# SERVICE No. 811A BULLETIN

Piper Aircraft Corporation  
Vero Beach, Florida, U.S.A.

Date May 12, 1986 S/M

Ammeter Replacement

SKETCH "A"

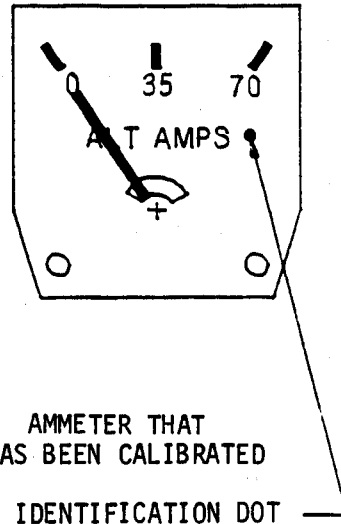
PURPOSE: Engineering tests have determined that a number of ammeter gauges shipped in support of Service Bulletin No. 811 were not correctly calibrated. Correctly calibrated gauges may be identified by the presence of a white dot located on the righthand side of the ammeter face, immediately following the word "AMPS". See Sketch "A" attached. Incorrect ammeter indications could lead to inadvertent overcharging and/or depletion of the aircraft's battery with subsequent loss of battery electrical power.

1. All aircraft which have complied with Service Bulletin No. 811 must inspect for the presence of a white dot on the righthand side of the ammeter face. See Sketch "A" attached.
2. If white dot is not present, the ammeter gauge, only, must be replaced with a correctly calibrated gauge.
3. Using applicable instructions for the Ammeter Replacement Kit, Piper Part Number 765-186, replace the newly installed ammeter only, with Ammeter, Piper Part Number 763-053.

NOTE: Upon completion of installation of ammeter in cluster housing, and prior to attaching the wires, check ammeter studs with ohmmeter to insure they are not grounded to the cluster housing.

4. Run engine and check out system.
5. Make appropriate logbook entry of compliance with this Service Bulletin.
